Ref. No.: HUS-CPB-SR-LTR-00002

Subject: Husky White Rose Development Project: New Drill Centre

Construction and Operations Program Environmental Assessment

Responses

Figure 3.3 Cross-sectional view of conceptual glory hole.

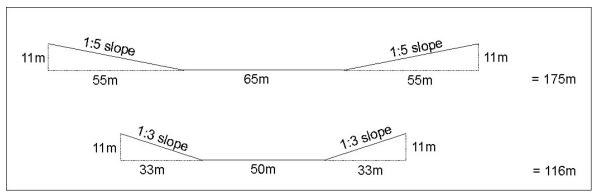
Section 7.6.2.2, Sediment Excavation, Page 72: The glory hole dimension presented $(70m \times 70m)$ is not a true reflection of the amount of area to be affected as it does not include ramp area (an additional $130m \times 70m$). The total area to be affected should be as accurate as possible.

The proposed glory holes differ in structure to the existing three glory holes (North, Central and South). The reference to a ramp area in Comment 3 is pertinent to the existing glory holes at the White rose location, which were designed to be excavated using a clam dredge. They have steep sides and a low-sloped ramp extending beyond the rectangular perimeter. The purpose of the ramp is to allow for a more level entry/exit of flowlines and umbilicals. See Figure 3.1 (attached), "White Rose Field Central Drill Centre (Detail), glory hole layout superimposed over bathymetry."

The proposed glory holes will have the ramps incorporated into the sides, such that in plan view (i.e. seen in Figure 3.2 (attached),) the glory holes will remain rectangular. Figure 3.2 (attached) represents a concept drawing of the North Amethyst Glory Hole based on the pre-FEED¹ study. This newer design will better facilitate the use of a suction dredge and will allow for a better flushing action, which in turn will provide better visibility for the ROV. This has been given for illustrative purposes only because these specifications are subject to change and further revision during the FEED study.

Dimensions given in the habitat compensation plan were based on the early pre-FEED design in which the basal area was $70 \, \text{m} \times 70 \, \text{m}$ and all four sides had a slope of 1:3 giving an overall area of $18900 \, \text{m}^2$. Recent revisions during the FEED study have modified the basal area to $65 \, \text{m} \times 50 \, \text{m}$, and at present the sides have a slope of either 1:3 or 1:5. This is an evolving process and the final dimensions have yet to be determined, however, the area to be compensated will be based on the final 'Approved for Construction' diagrams as soon as they become available.

The following calculations are based on the most recent data from Husky's Development and Project Engineering Groups. A glory hole must be a minimum of 10m deep. Instruments used during dredging to measure the depth have inherent measuring errors of ± 0.5 m, thus the depth will be dredged to 10.5m. For the purposes of area calculation we have rounded up to 11m therefore overestimating the intended area by over 5%. The sides slope upwards from the glory hole bottom to the seafloor at a slope of either 1:3 or 1:5. The 1:5 gentler slope serves as ramps for the umbilicals and flowlines entering/exiting the glory hole. The attached Figures 3.2 and 3.3 show the proposed glory hole structure and dimensions based on a 65m $\times 50$ m, 11m deep glory hole. The overall dimensions at seafloor level would be 175m $\times 116$ m for an overall conservative estimated area of 20300m².
